Contract Change Order # 2

Project Name: 37th Street: Albany to Omaha & RWD#4 Waterline Project Number: ST1507
 Project Location: 37th Street Albany to Omaha Date of Application: Monday, August 7, 2017
 Contractor: Paragon Contractors, LLC Submitted By: Jeremy J. Kelly

Work Change Directive

Wagoner County Rural Water, Sewer, Gas, Solid Waste Management, District No. 4
209th Waterline
CHANGE ORDER

WATERLINE PLAN & PROFILE (1)
 WAGONER COUNTY RURAL WATER DIST. #4
 STA. 10+00 TO STA. 16+00

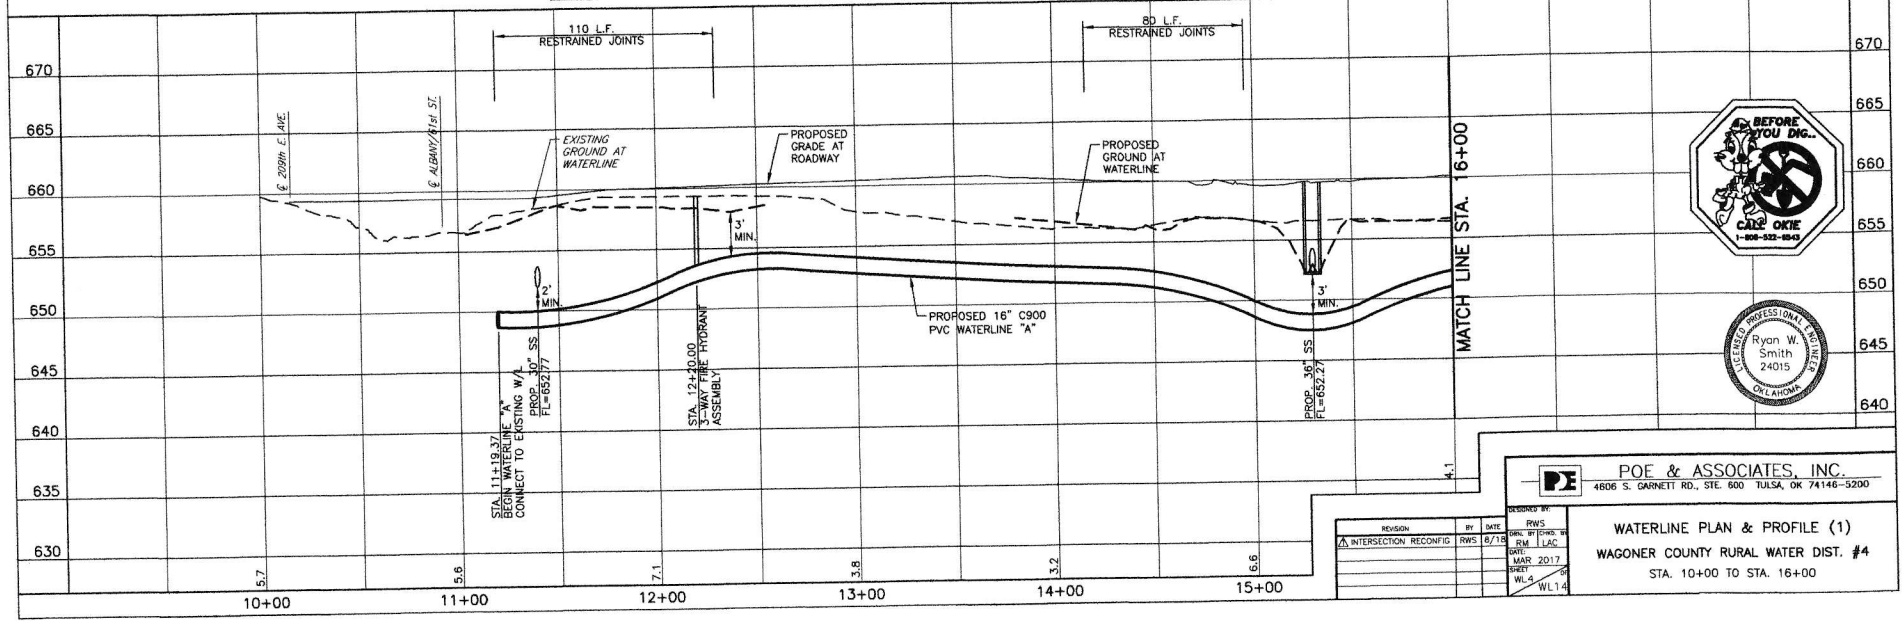
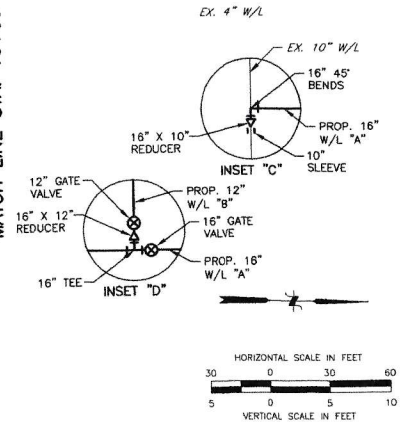
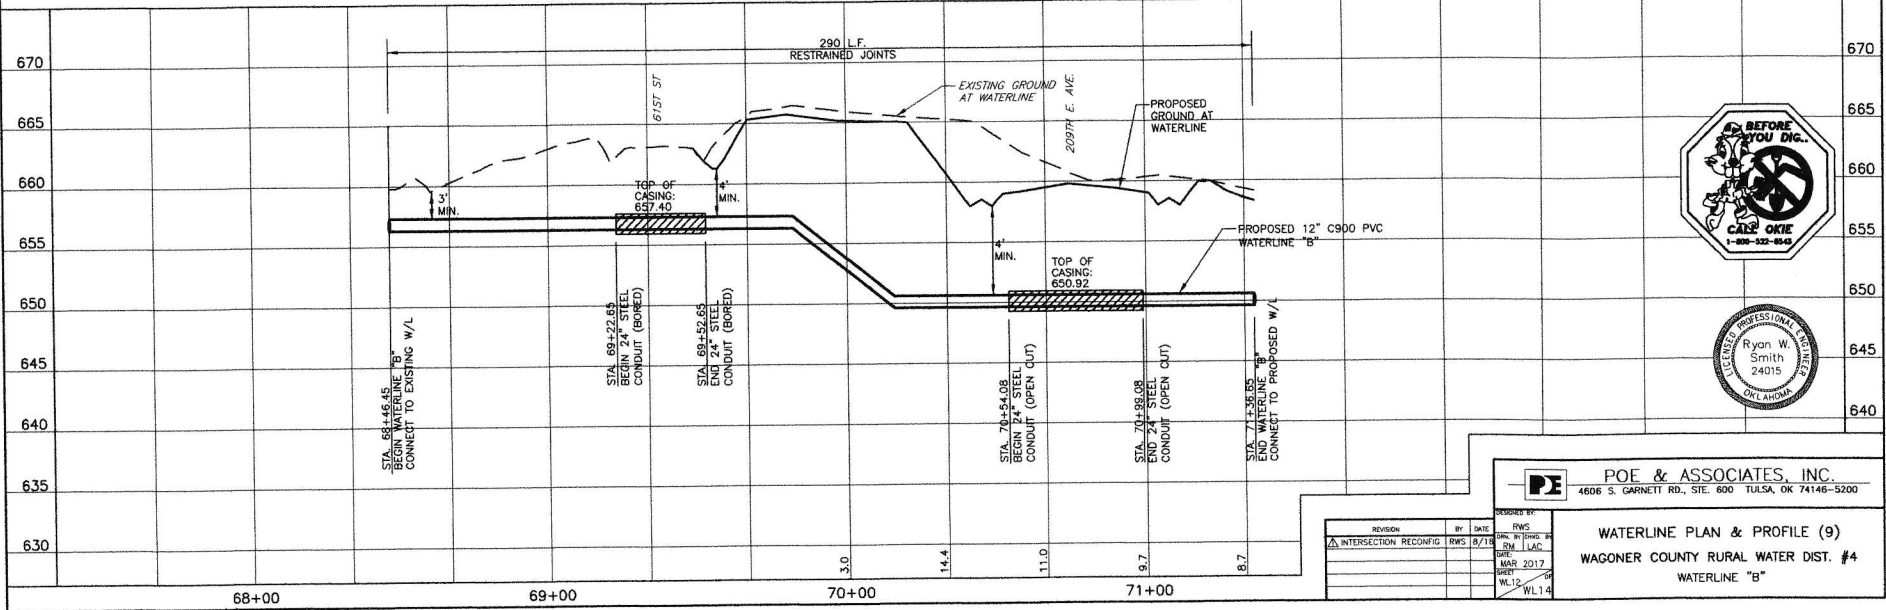
At the junction of 61st and Albany, the configuration of the waterline has been revised by Poe and Associates per the RWD #4's direction. Please see attached for the revised plan sheets, slip sheet these into the existing plans and proceed with construction. This change underruns and overruns existing quantities to a deficit on the contract, but will require a change order for the new item of 24" conduit (bored) as well as the new automatic flusher. Please provide these two new item costs within a separate cost change proposal. The deduct cost noted above is an estimation utilizing standard market values for the estimation purposes only. Also the attached change order document is for reference only to show the estimated change in quantities.

REQUESTED CHANGES AND REASONS
Modification to the intersection at 61st and 209th.

REVISION	BY	DATE	DESIGNED BY
INTERSECTION RECONFIG	RWS	6/16	RM
			LAC

STA. 11+19.37
 CONNECT TO EXISTING 10" W/L
 1 - 16" X 10" REDUCER, R.J.
 1 - 10" SLEEVE, R.J.
 2 - 16" 45° BENDS, R.J.
 N=399244.3699
 E=2635205.3848

STA. 11+61.48
 CONNECT TO PROP. 12" PVC W/L "B"
 1 - 16" X 16" X 16" TEE, R.J.
 1 - 16" X 12" REDUCER, R.J.
 1 - 12" GATE VALVE & BOX, R.J.
 2 - 16" GATE VALVE & BOX, R.J.
 N=399286.4529
 E=2635204.0991

STA. 12+20.00
 1 - 3-WAY FIRE HYDRANT
 ASSEMBLY, R.J.
 N=399344.9601
 E=2635202.6953

STA. 14+40.98
 1 - 16" 45° BEND, R.J.
 N=399585.8593
 E=2635196.7892

STA. 14+70.98
 1 - 16" 45° BEND, R.J.
 N=399591.4389
 E=2635181.1148

WATERLINE PLAN & PROFILE (9)
WAGONER COUNTY RURAL WATER DIST. #4
WATERLINE "B"

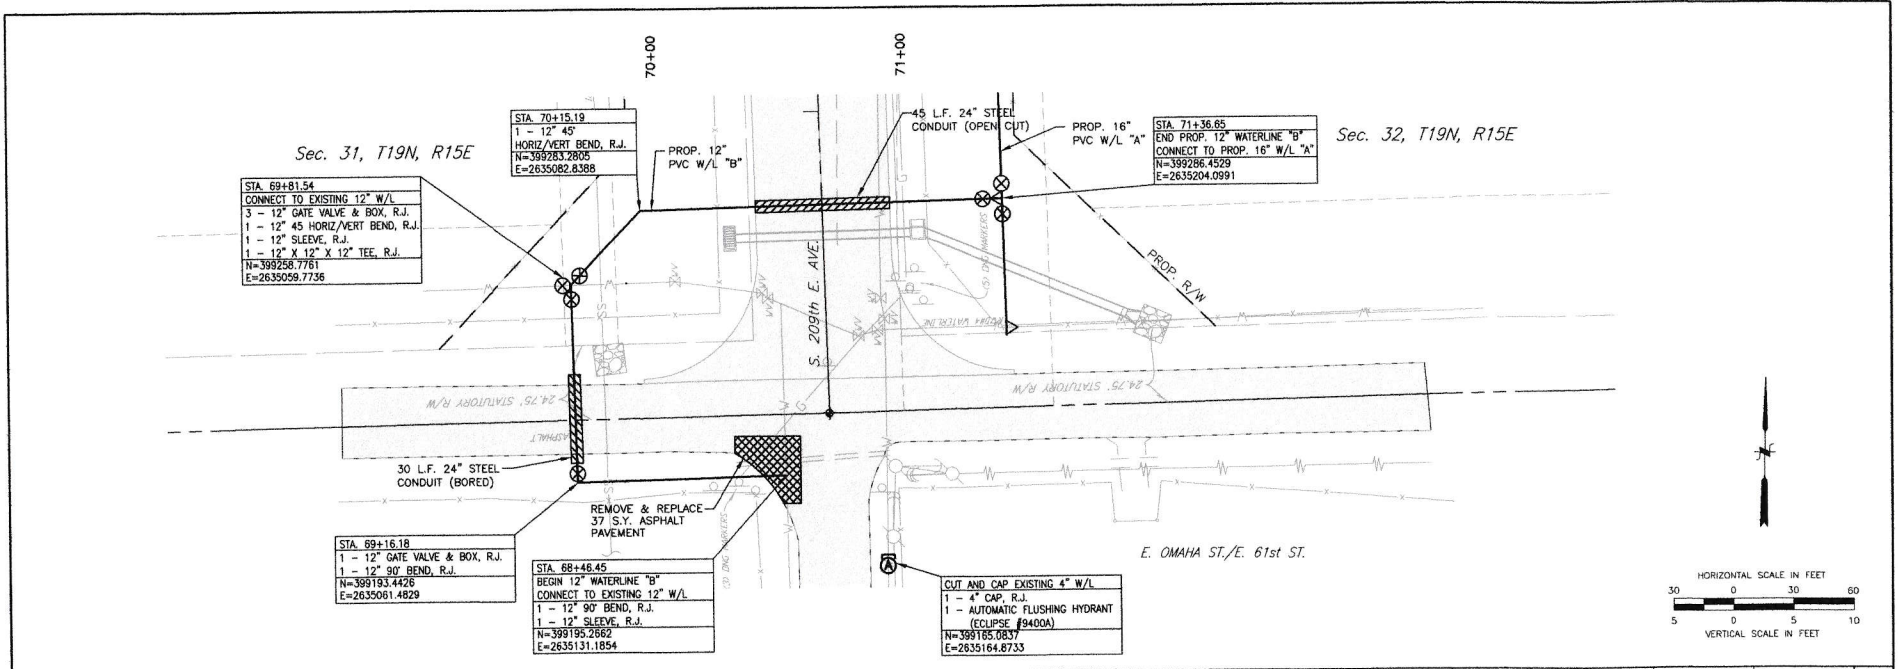
REVISION	BY	DATE	RWS
INTERSECTION RECONFIG	RWS	8/15	RM
			LAC
